REVISION TRANSMITTAL

This sheet transmits Revision 1 to SB525B-34-32, which:

SB525B-34-32

NAVIGATION - GARMIN SOFTWARE UPDATE TO VERSION 4.8.11

Figure 1. Wiring Modification (Sheet 1)

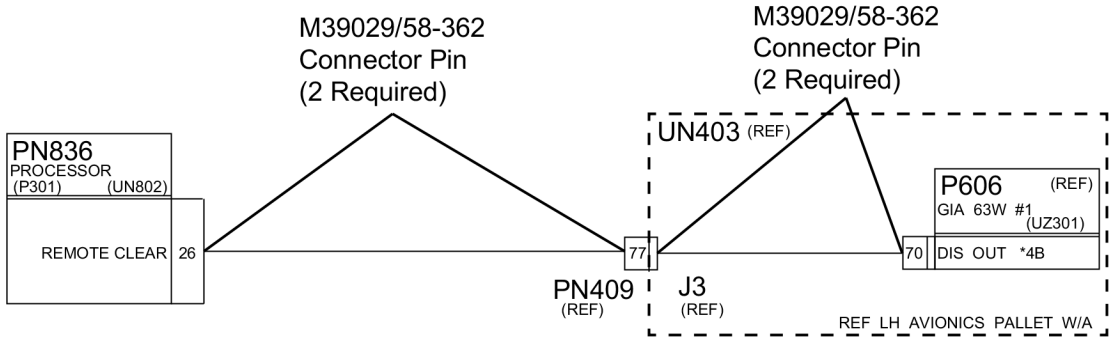
4. (Airplanes equipped with the Stormscope option) (Refer to Figure 1.) Modify the wiring.
 - A. Open the left nose baggage compartment door.
 - B. Remove nose baggage compartment panels 211IZ and 211HZ to get access to the left GIA 63W Integrated Avionics Unit. (Refer to the Model 525B Maintenance Manual, Chapter 6, Access Plates and Panels Identification - Description and Operation.)

- F. Remove the PN836 electrical connector from the Stormscope processor and the P606 electrical connector from the left GIA63W Integrated Avionics Unit.

- G. Install the 26PN836-77PN409 Electrical Wire with two MS39029/58-362 Connector Pins.
 - H. Install the 77J3-70P606 Electrical Wire using two M39029/58-362 Connector Pins.

- I. Install the PN836 electrical connector in the Stormscope processor and the P606 electrical connector in the left GIA63W Integrated Avionics Unit.
